UNITED STATES
DEPARTMENT OF THE INTERIOR
BUREAU OF LAND MANAGEMENTFORM APPROVED
OMB No. 1004-0137
Expires: July 31, 2010**SUNDRY NOTICES AND REPORTS ON WELLS**
Do not use this form for proposals to drill or to re-enter an abandoned well. Use Form 3160-3 (APD) for such proposals.5. Lease Serial No.
NMNM033775

7. If Unit of CA/Agreement, Name and/or No.
NMNM70993X8. Well Name and No.
North Benson Queen Unit #469. API Well No.
30-015-2634510. Field and Pool or Exploratory Area
Benson Queen Grayburg North11. Country or Parish, State
Eddy

RE: Plugging and Abandonment Requirements, Conditions of Approval

WELLBORE SCHEMATIC

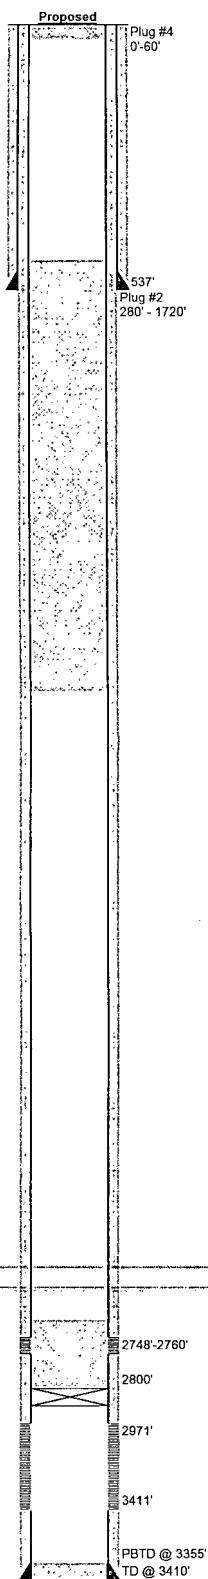
1. MIRUPU NDWH NUBOP
2. Clean out to 2900', circ. hole clean w/2% KCl substitute
2. RIH w/CIBP and set @ 2800', spot 25 sks class C cement on to of CIBP
3. Spot 150 sks class C cement from 270' - 1720'. WOC and Tag
4. Spot plug from 60' to surface.
5. Cut off wellhead and install dry hole marker

1. OK
2. OK
3. Move: CIBP to be set no more than 100' above perfs (2871'). WOC and tag at 2600' or shallower (approx 30sx) – Otherwise OK (Perfs)
4. Tag at 270' or shallower – Otherwise OK (Yates – BOS – TOS – Casing shoe)
5. OK (Surface)
6. Verify that all annuluses have cement to surface and fill in as required. Ground level dry hole marker shall be used in the area; Requirements attached – Otherwise OK
7. Submit a subsequent report to the BLM.
